ROCKY FLATS SITE

REGULATORY CONTACT RECORD 2021-05

Purpose: East Trenches Plume Treatment System (ETPTS) Discharge Gallery Replacement

Figure 1. ETPTS Discharge Gallery Overview

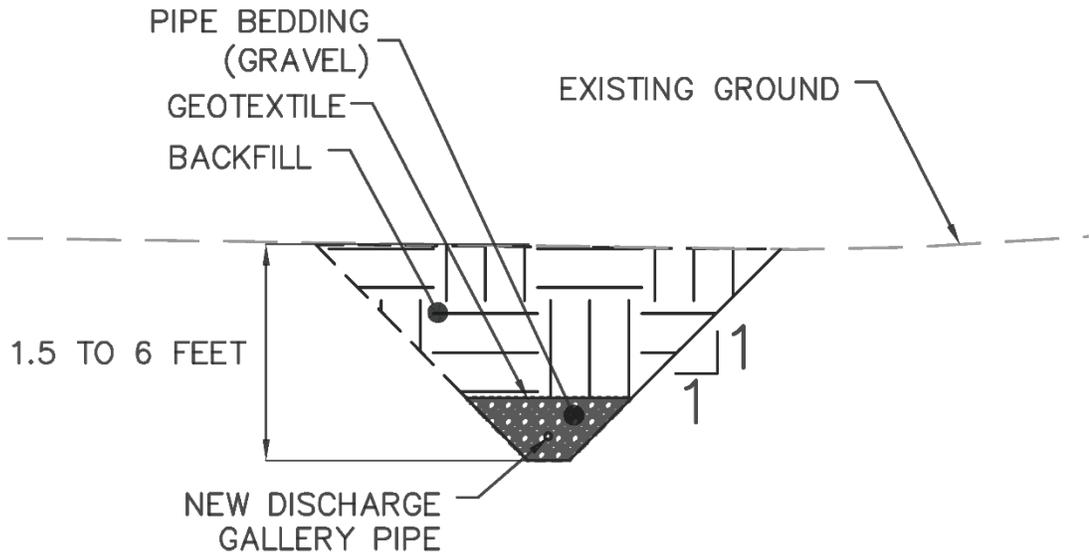
The ETPTS discharge gallery is due for periodic maintenance. DOE plans to replace or remove components of the ETPTS. These components include all effluent piping from the flow control vault to and including the discharge gallery (Figure 1). The only component of the system that will be removed and not replaced is the former effluent metering manhole between the flow control vault and the discharge gallery (Figure 1). That manhole was formerly used by workers to make flow measurements; flow measurement is now performed using in-line flow meters at other locations within the system.

CDPHE, after consultation with EPA, has approved the activities described in this contact record (CR). Based on the information provided, CDPHE determined that the proposed activities will not result in an unacceptable release or exposure to residual subsurface contamination and will not damage any component of the remedy. CDPHE has also determined that the proposed activities meet the rationale and objectives of IC 2.

Figure 2. Project Excavation Cross Sections

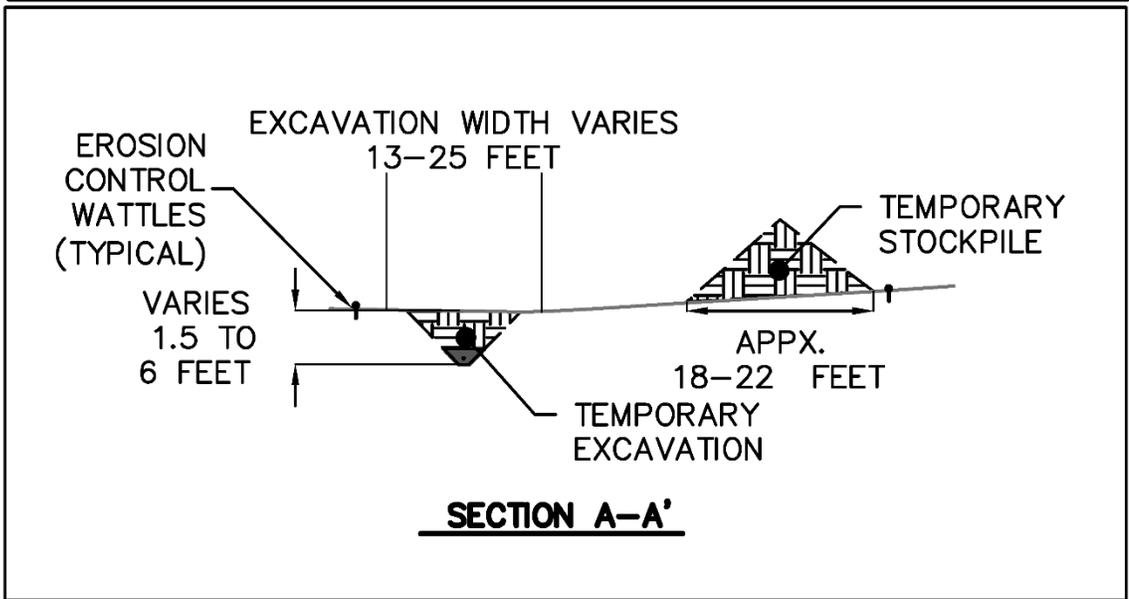
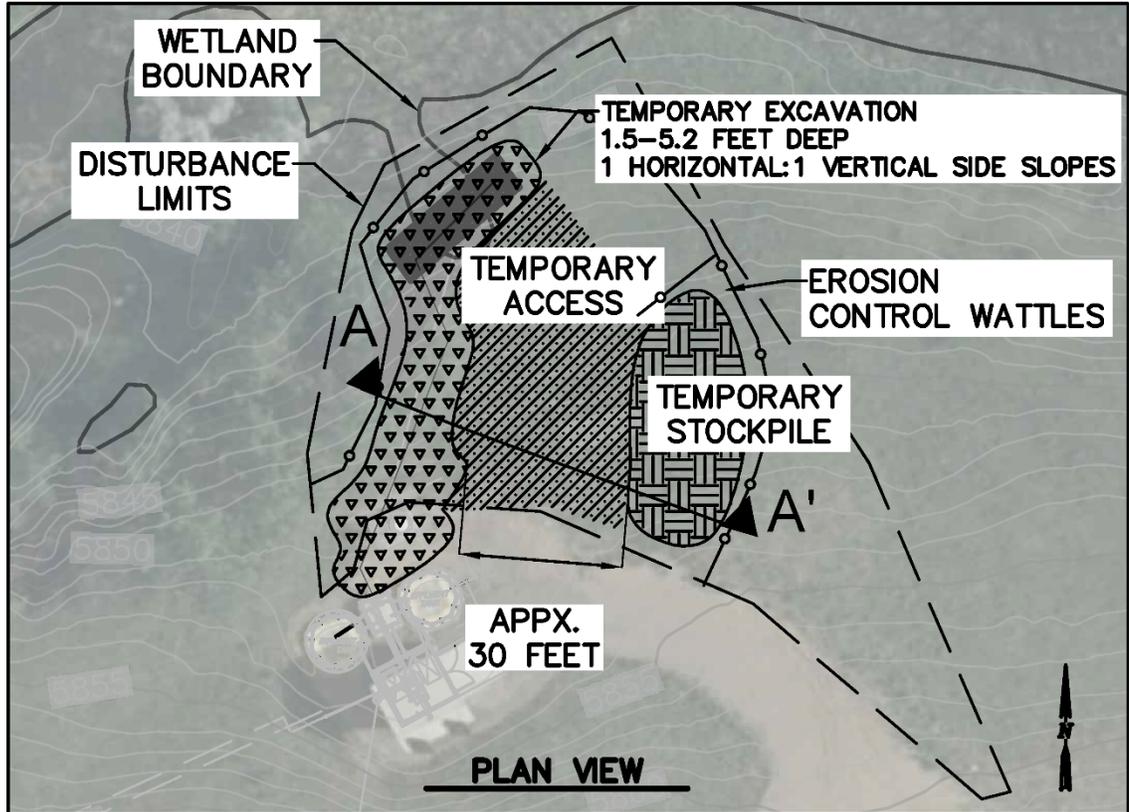
With the ETPTS turned off, DOE will excavate and remove the effluent metering manhole and all subsurface piping, which vary in depth from 1.5 to 6 feet (ft) below grade (Figure 2). Based on DOE's review of site records and information, there are no subsurface structures in this area or soil contamination. Once these are removed, the new pipe will be installed at similar depths ranging from 1.5 to 6 ft. The new pipe will follow a similar path as the old piping with some deviations, such as eliminating the use of 90-degree angles and no longer passing through the metering manhole. The path deviations, the elimination of 90-degree angles, and other system improvements are designed to maintain higher flow velocity, which is expected to reduce future scale buildup within the piping.

The ETPTS component replacement and removal will require excavations ranging from 1.5 to 6 feet. The extent of the required excavations is shown in Figures 2 and 3 of CR 2021-05.
